Subject: Proposed Silesia Properties, L.P. Permit No. WQ0015835001

I am submitting these comments on behalf of the Greater Edwards Aquifer Alliance regarding the Texas Land Application Permit (WQ0015835001) proposed for Silesia Properties, LP. The propose permit would authorize wastewater treatment and subsurface drip dispersal system disposal for 0.365 million gallons per day into the Honey Creek watershed upstream of the Honey Creek State Natural Area.

TBPE Firm No. F4092

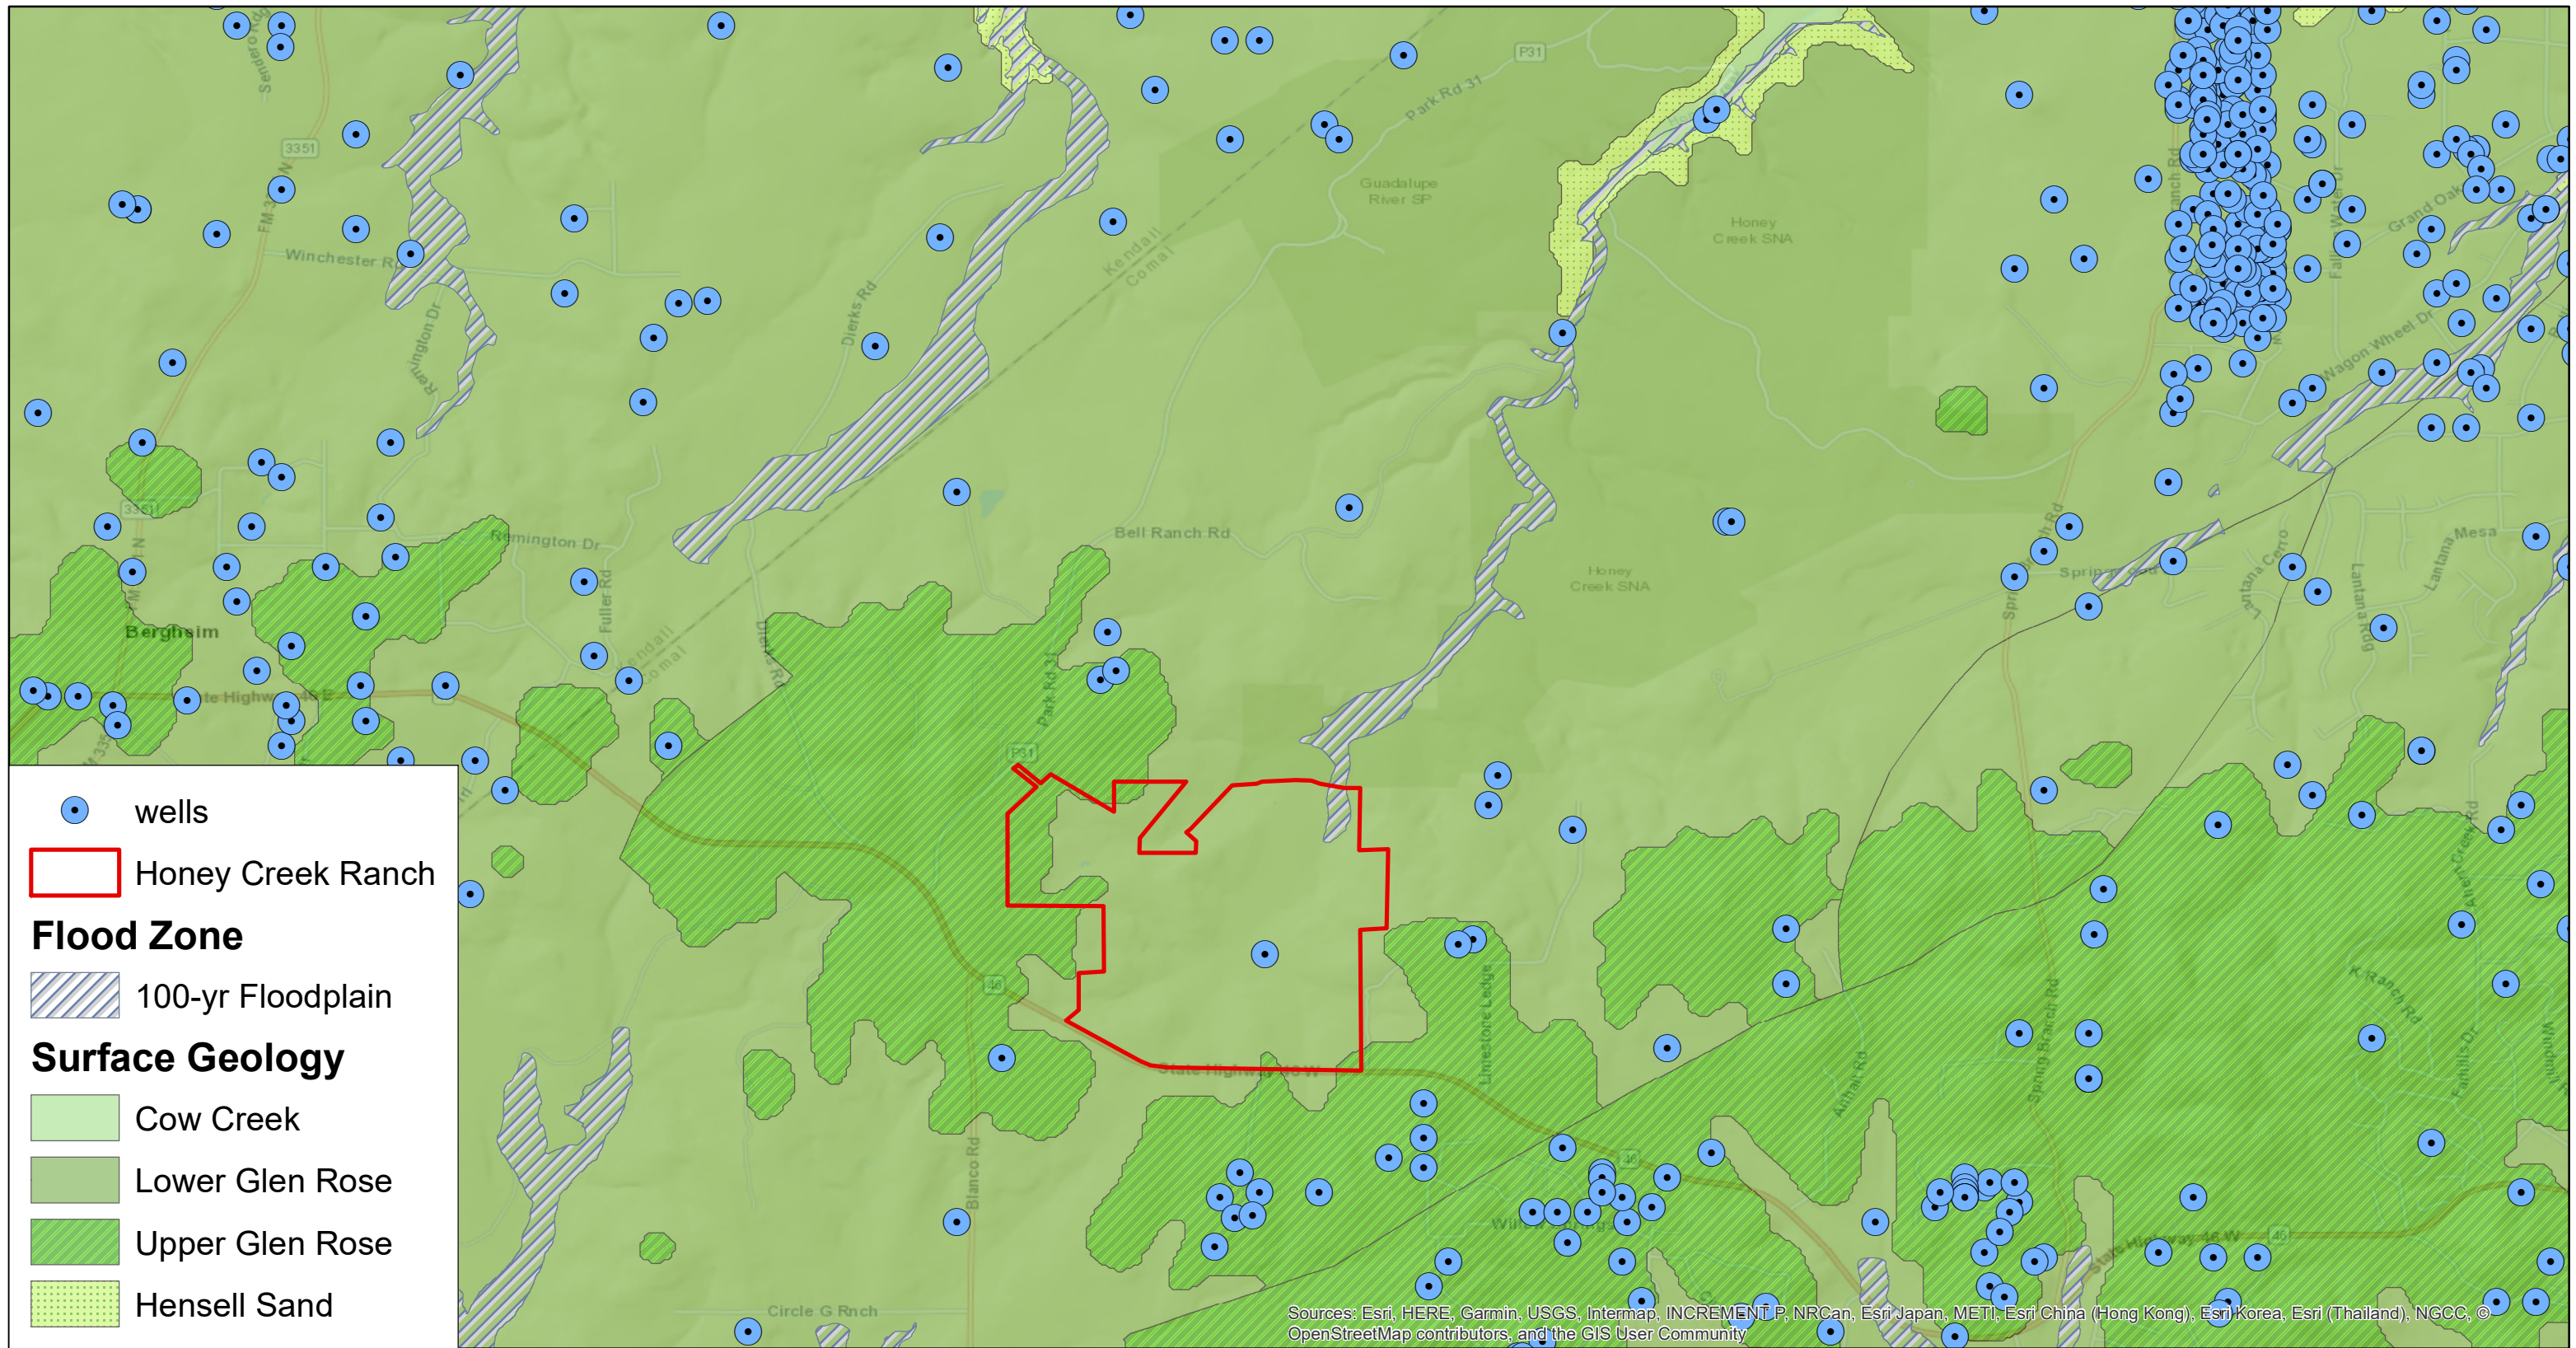
Figures 2, 3 and 4 show the low natural nutrient concentrations in unimpacted streams northwest, north, and northeast of the proposed discharge. Effluent nutrient concentrations that could be legally discharged under the proposed draft terms are significantly higher than these natural concentrations.

The proposed wastewater permit would allow effluent with nutrient concentrations as much as several hundred to a thousand times higher than those measured in unimpacted Texas hill country streams. Even using land effluent disposal and stream dilution, the proposed permit terms would not control degradation from significant increases in stream nutrient concentrations. As demonstrated in the paragraphs below, stream degradation from escalating nutrient loads into Texas hill country streams have been observed and documented for other land disposal wastewater systems. See my report in Attachment 2.

Figure 5. Surface Geology and Wells

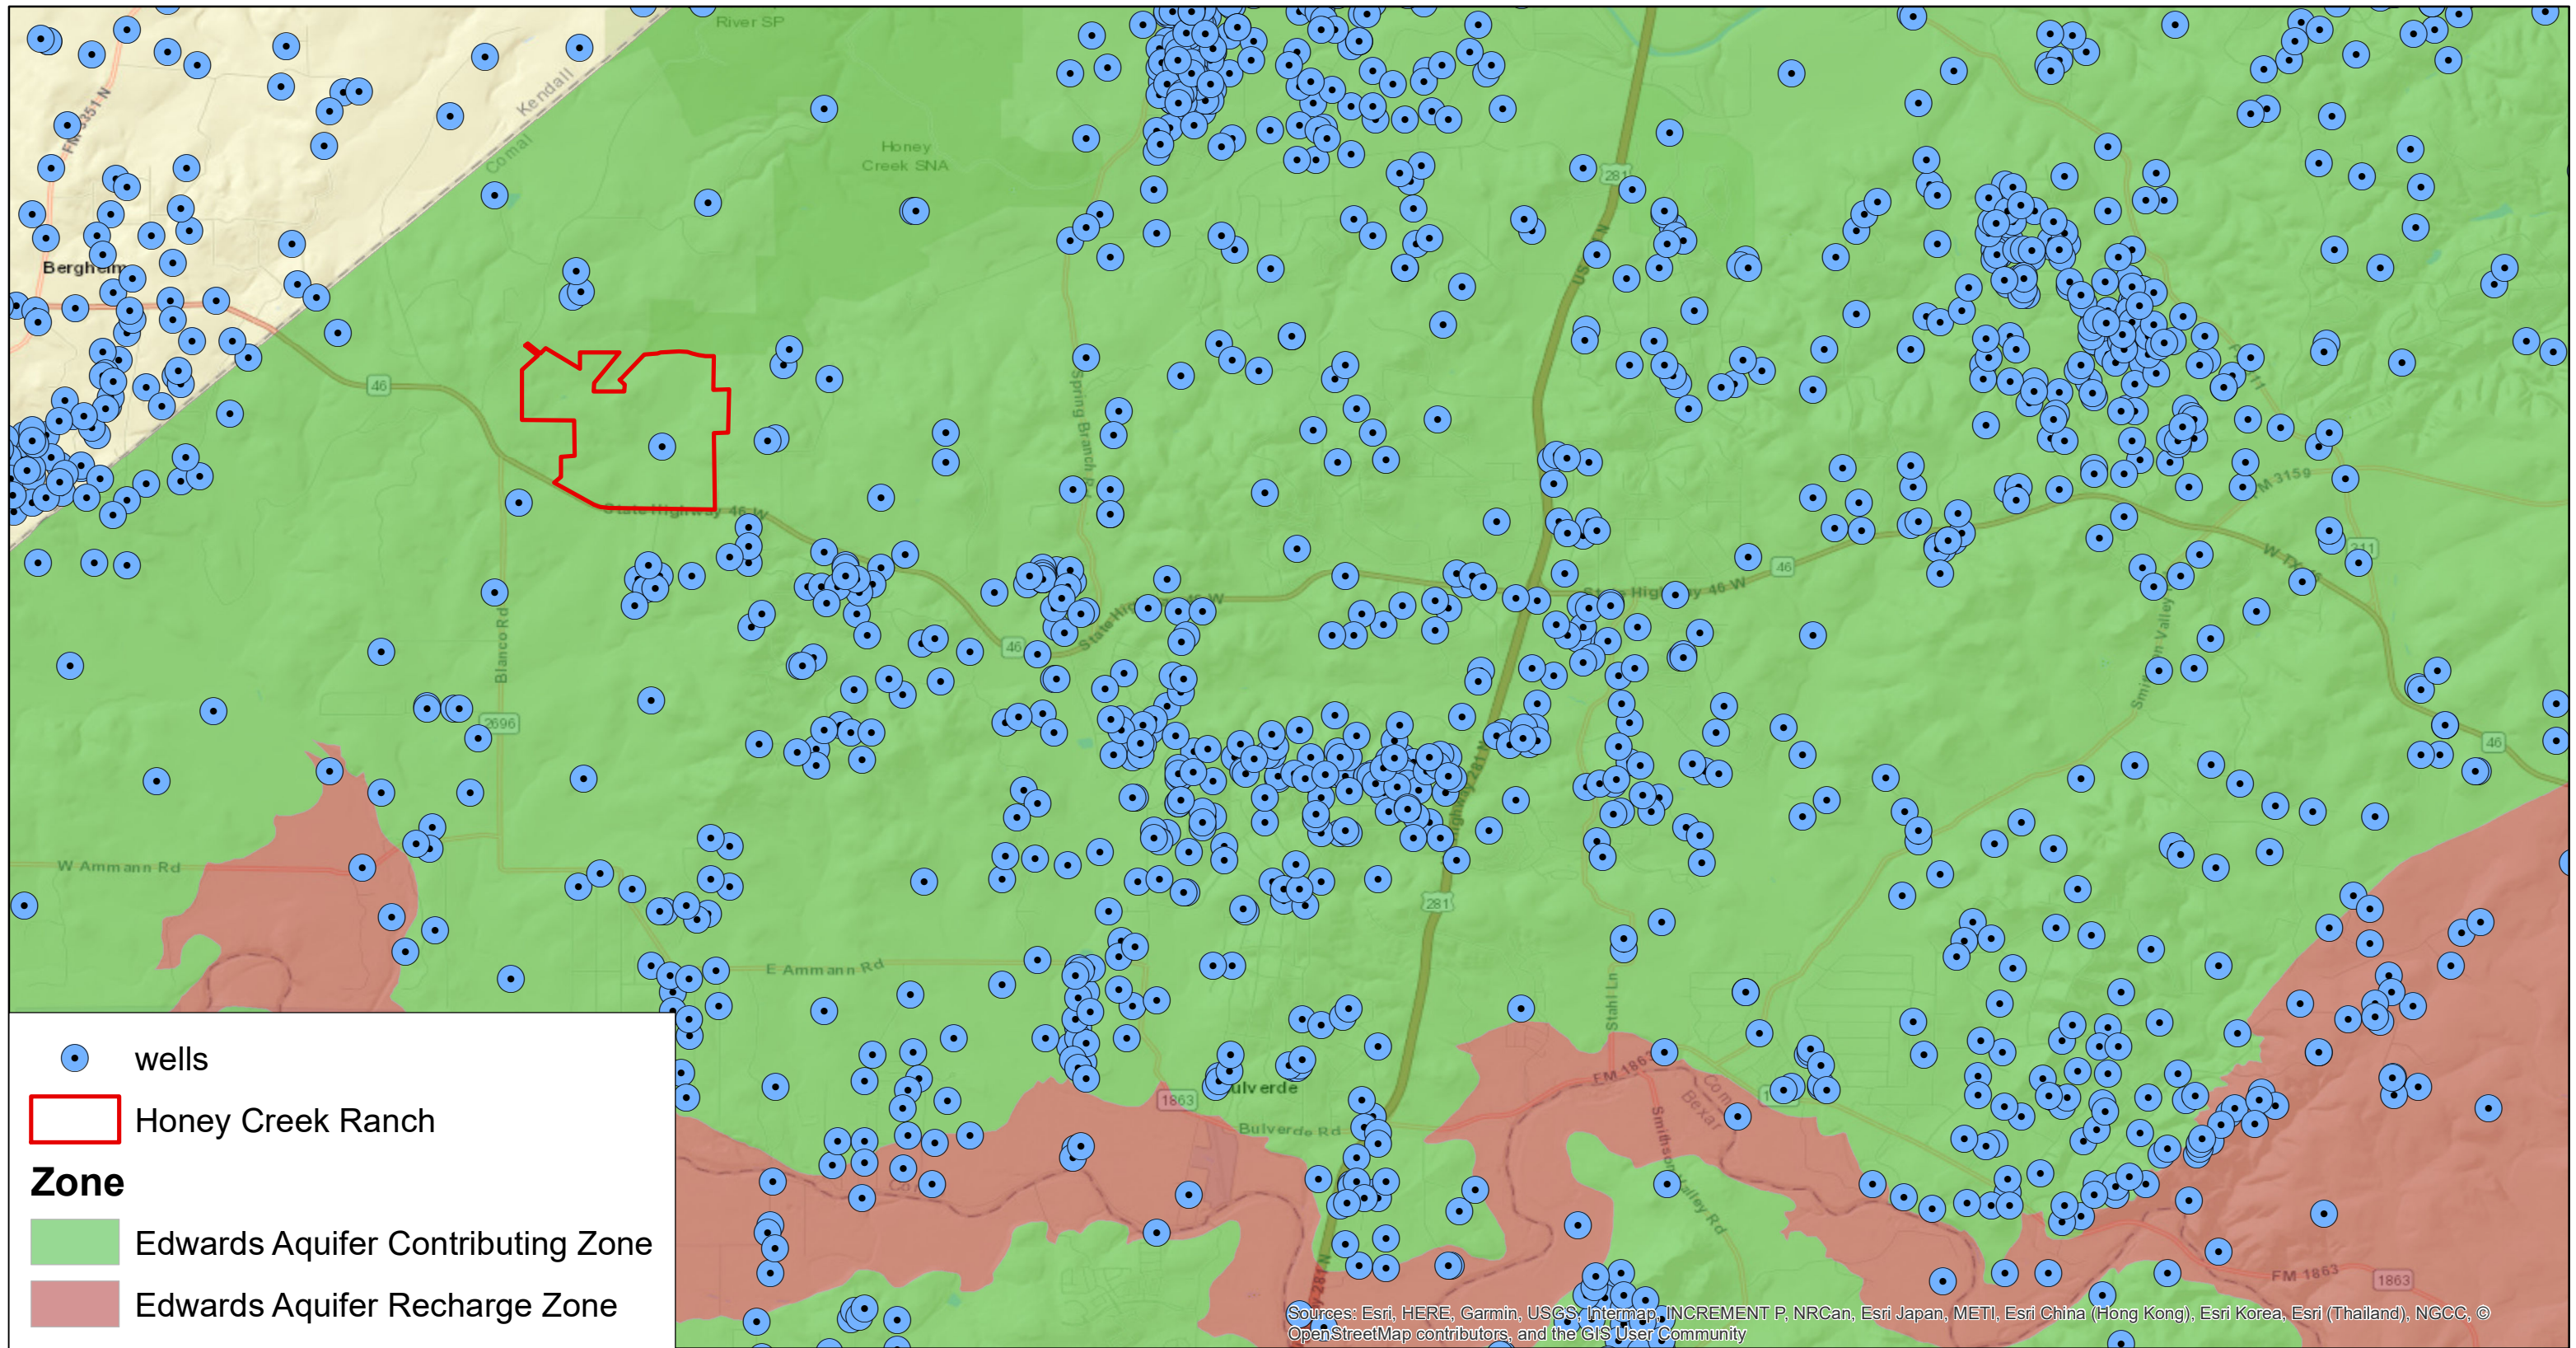
The Lower Glen Rose Formation forms part of the Trinity Aquifer and locally provides water supply to numerous public and private wells. Wells near the proposed wastewater system are also shown on Figure 5.

Wells in the vicinity of the proposed sewage treatment and disposal are completed in the Trinity Aquifer. There is no laterally extensive confining bed or aquaclude within the Trinity Aquifer to impede the downward migration of effluent. Wastewater effluent would percolate to deeper groundwater zones, potentially migrating into the underlying aquifer and contaminating water wells.

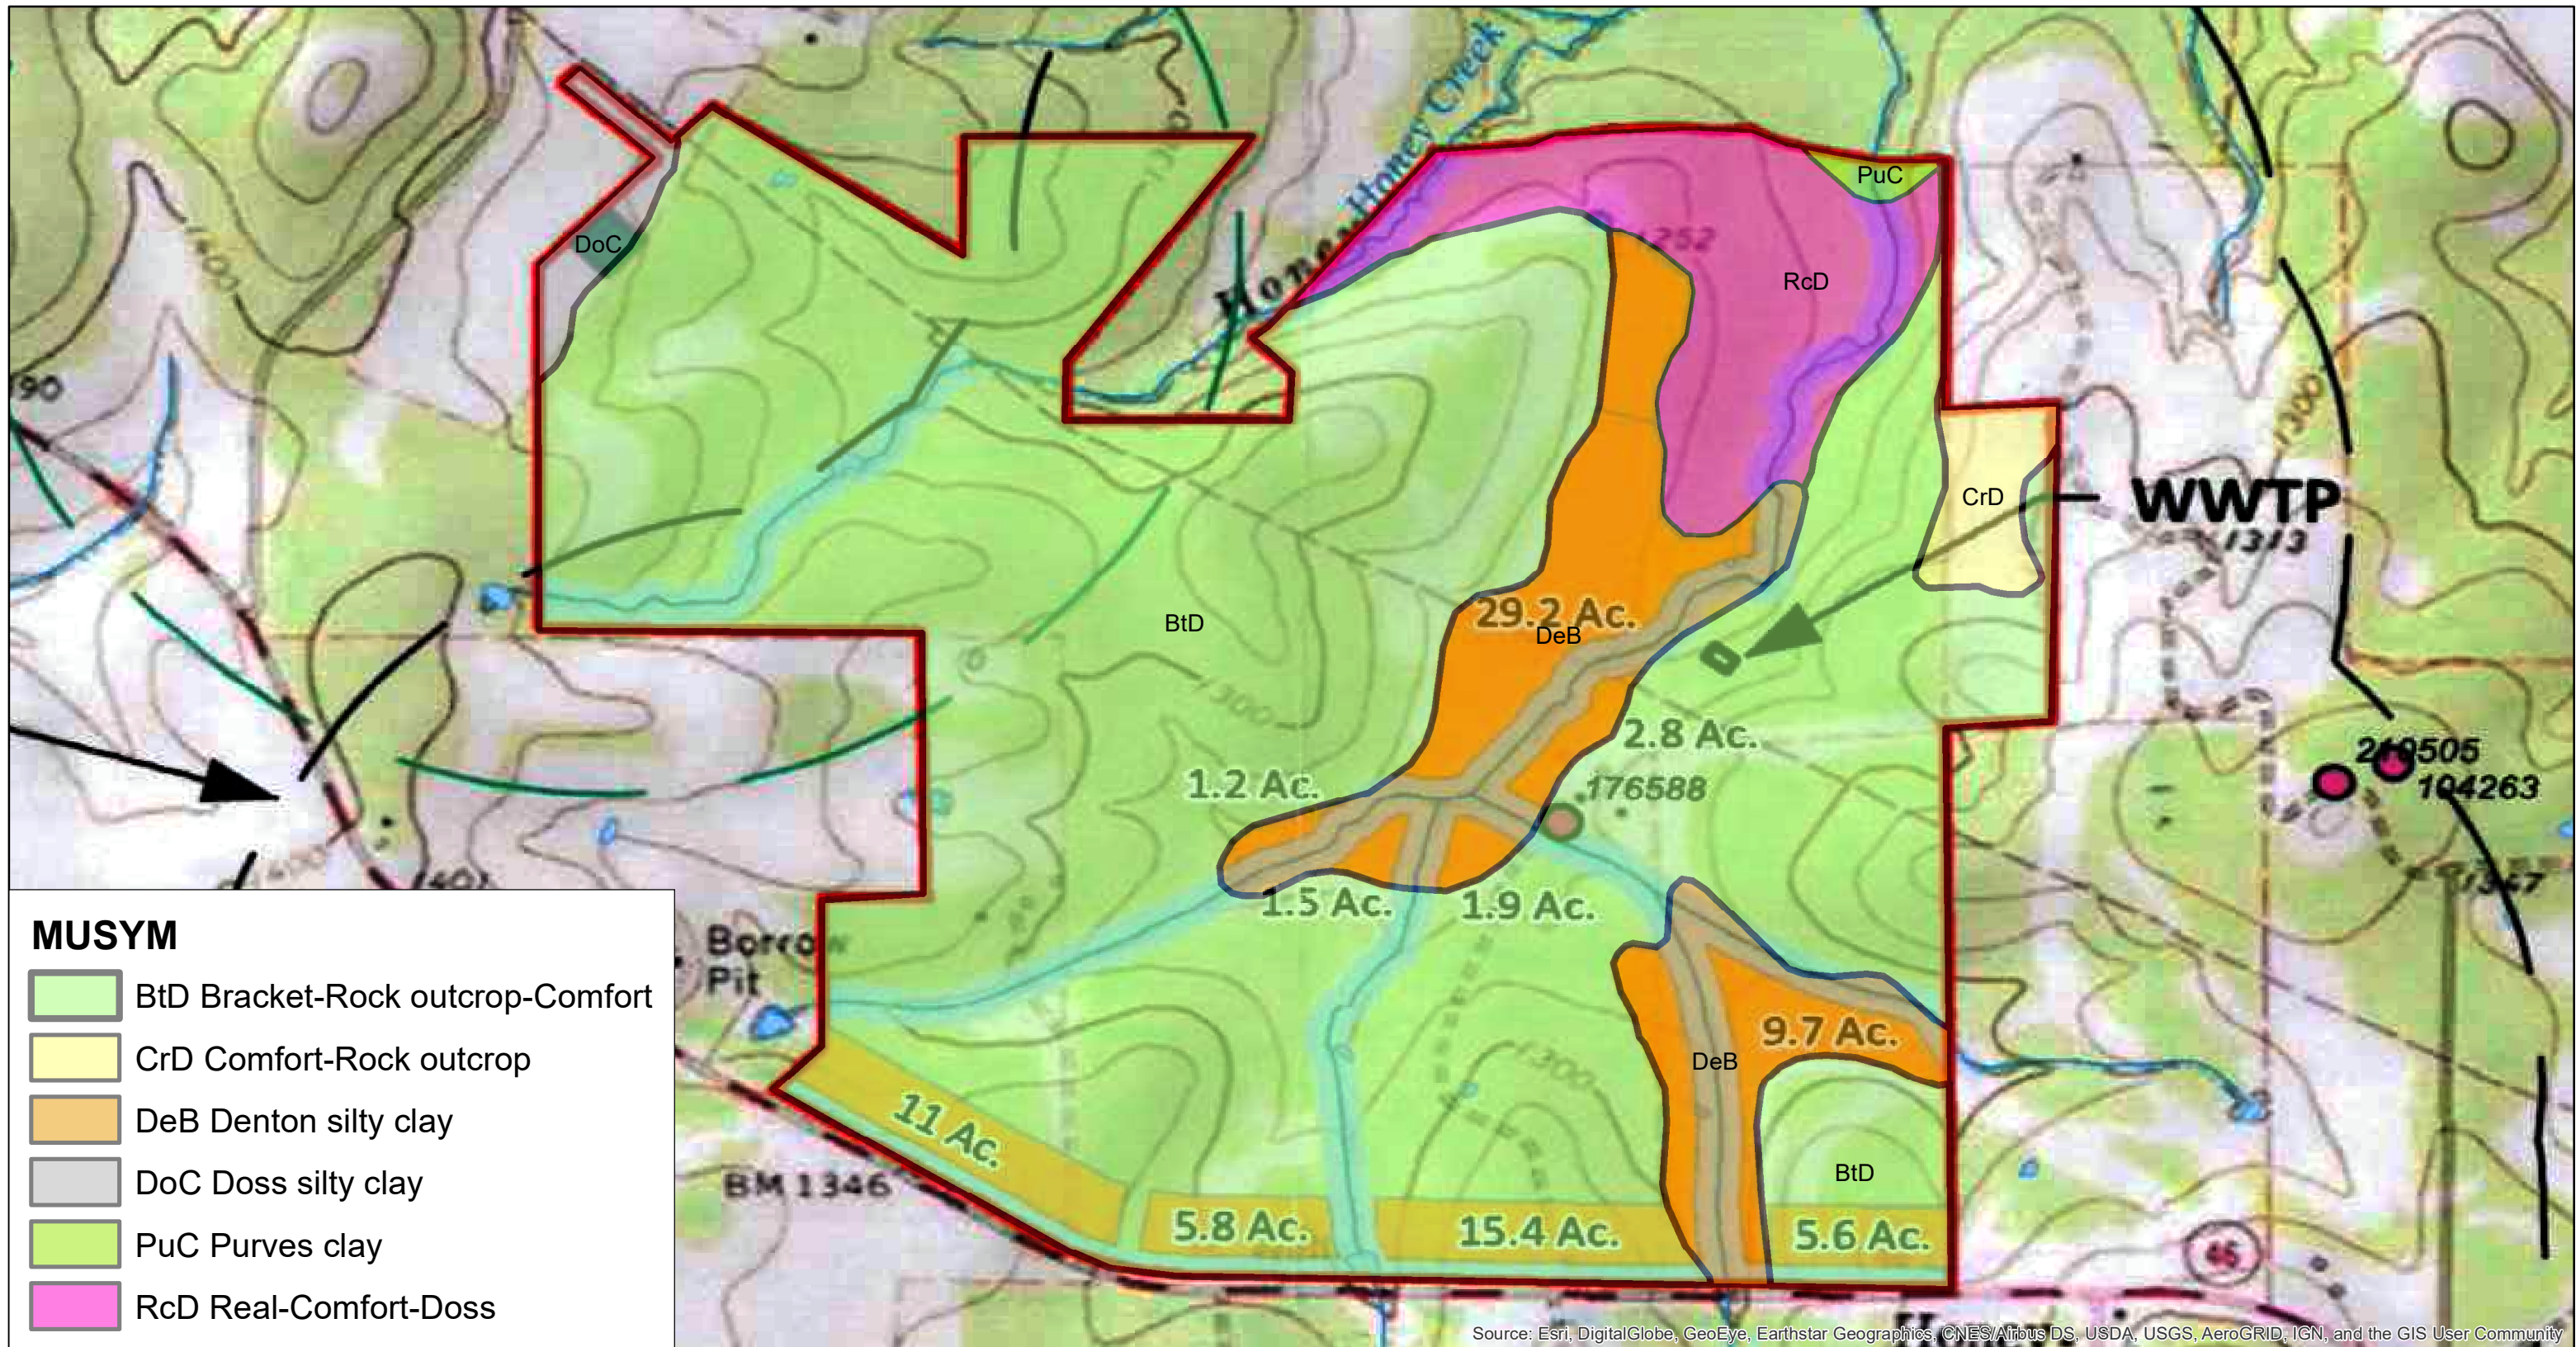
I have performed a preliminary water balance for 365,00 gallons per day of effluent disposed onto 84 acres. In conducting this water balance, I used site-specific soil properties published by the Natural Resources Conservation Service for the proposed effluent disposal areas. The water balance uses daily precipitation and evapotranspiration from January 1, 1954 through December 31, 2014 to determine the daily volume of effluent that can be accommodated up to the point of saturated soils. Volumes in excess of the soil's saturated capacity cannot, under the terms of the permit, be irrigated. The model calculates these excess effluent volumes.

My preliminary calculations indicate that effluent ranging from 11 percent to 30 percent of the proposed effluent volume, on an annual basis, would not be accommodated within the proposed storage volume and disposal area without oversaturating soils. Wastewater effluent would exceed the proposed system capacity for 69 to 157 days in each of the 61 years from 1954 to 2014.

The total volume of excess effluent over this 61-year period would be 1.8 **billion** gallons. Twenty-two percent of the proposed effluent volume proposed in the permit would be either irrigated onto saturated soils or else pumped and hauled to another treatment facility.

The proposed 84-acre effluent disposal area would be sufficient to dispose of 150,000 gallons per day of effluent, without over-saturating soils, if effluent storage was increased to 8.5 million gallons.
